Catherine Hill Bay Water Utility

New Infrastructure Audit (Stage 2 Scheme)

Independent Pricing and Regulatory Tribunal

November 2018

Figure A.4.3 SCADA setpoint screen for Instrument AIT1051 MBR Permeate Turbidity (CCP3)

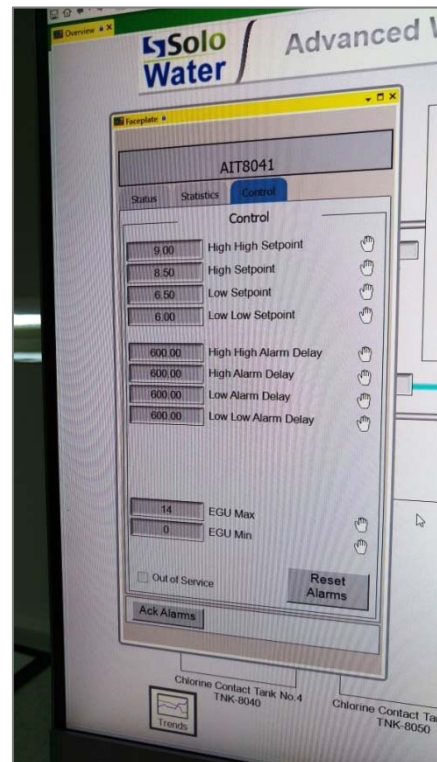
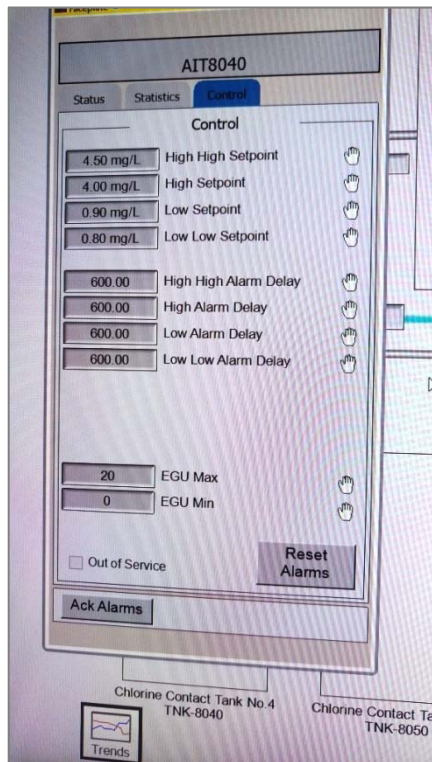
It is noted (refer Figure A.4.3) that units shown on the setpoint screen for Instrument AIT8011 UV Intensity are incorrectly shown as W/cm², although the values are correct and the correct units (W/m²) are shown on the UV System Status mimic screen. As an opportunity for improvement (**OFI-CHB2-NIA.01**), it is suggested that Catherine Hill Bay Water reviews the SCADA system setup to ensure that the correct units are displayed on the AIT8011 UV Intensity setpoint screen.

- **OFI-CHB2-NIA.01:** It suggested that Catherine Hill Bay Water reviews the SCADA system setup to ensure that the correct units are displayed on the AIT8011 UV Intensity setpoint screen.
-
